UNITED STATES PATENT AND TRADEMARK OFFICE

APPLICATION NO.	FILING DATE	FIRST NAMED INVENTOR	ATTORNEY DOCKET NO.	CONFIRMATION NO.
10/059,311	01/31/2002	Kyung Chul Woo	3449-0190P	5488
2292	7590	08/06/2004	EXAMINER	
BIRCH STEWART KOLASCH & BIRCH			JAGAN, MIRELLYS	
PO BOX 747			ART UNIT	PAPER NUMBER
FALLS CHURCH, VA 22040-0747			2859

Office Action Summary	Application No. 10/059,311	Applicant(s) WOO ET AL.	
	Examiner Mirellys Jagan	Art Unit 2859

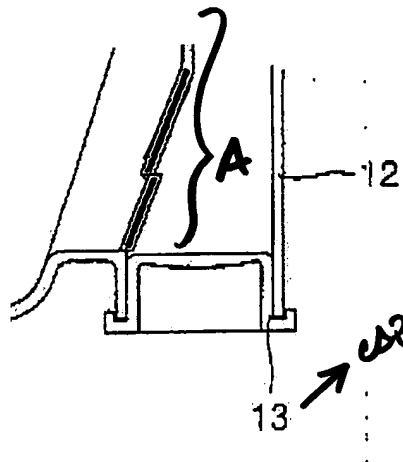
1. Claims 5, 6, and 9 are objected to because of the following informalities:

There is lack of antecedent basis in the original disclosure for the cap overlapping the tapered portion of the outer tub, as claimed in claims 5 and 9 (see figure 1(b) below, for example, which shows that the hollow cap does not overlap the tapered portion (A) of the outer tub).

Claim 6 is objected to for being dependent on objected base claim 5. Appropriate correction is required.

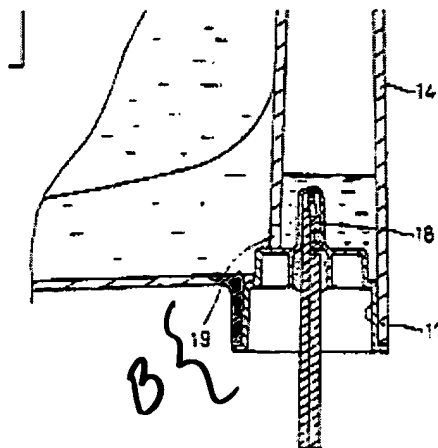
a water temperature measuring part including a temperature sensor (18) and signal lines for connecting the sensor to a circuit for measuring a temperature of water;

a water gauge chamber (14) extending along an outer side of an outer edge of an outer tub (2) of the washing machine; and

a hollow chamber cap (17) that is located at a bottom edge of the water gauge chamber to close an opened bottom portion of the gauge chamber, the cap having an upper side that is substantially flat, wherein substantially an entire upper surface of the of the upper side is exposed to the water;

wherein a lower surface of the upper side is formed with a recess serving as a seating portion in which is mounted the temperature measuring part so that the temperature of the water is measured without the sensor directly contacting the water; a hollow space of the cap faces downward and the water in the gauge chamber is above the cap; and a lower portion (labeled B in figure 3 shown below) of a side of the outer tub is tapered inwardly toward a bottom of the outer tub such that the cap overlaps the portion tapered inwardly (see figures 2 and 3).

Furthermore, the term “substantially” is considered to be a relative term, and since the specification does not provide a standard for ascertaining the requisite degree, the upper side of the cap disclosed by Yamamoto is considered to be substantially flat and have a substantially entire upper surface exposed to the water.
